# Allowing Eq 145-8 to be tested-missing Icon-2P\_other definition

July 2017  
Rev001  
Yair Darshan

$I_{con-2P_{unb}}$  vs  $I_{con-2P_{unb\_actual}}$

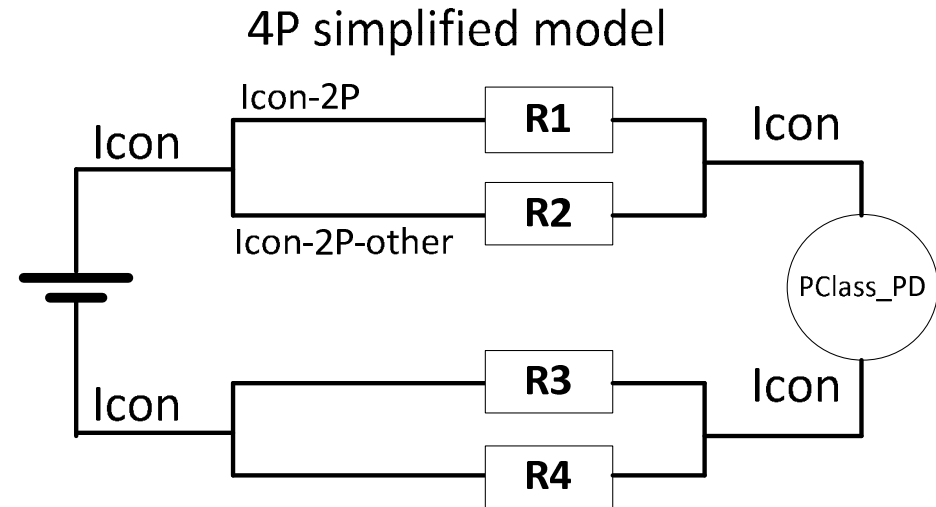
- $I_{con} = P_{Class} / V_{pse}$
- $I_{con} = I_{con-2P} + I_{con-2P-other}$
- $I_{con-2P_{unb\_actual}} = V_{pse\_min} * I_{con} * (1 + R_{unb}) / (2 * V_{pse})$   
for the range 50V to 57V.
- $R_{unb} = (R1 - R2) / (R1 + R2)$ ,
- If  $R2 > R1$ ,  $I_{con-2P} = I_{con-2P_{unb\_actual}}$
- If  $R1 > R2$ ,  $I_{con-2P-other} = I_{con-2P_{unb\_actual}}$
- $I_{con-2P_{unb}} = I_{con-2P_{unb\_actual}} = 0.682A$  for Class 6 at 50V and worst case  $P_{Runb}$ .
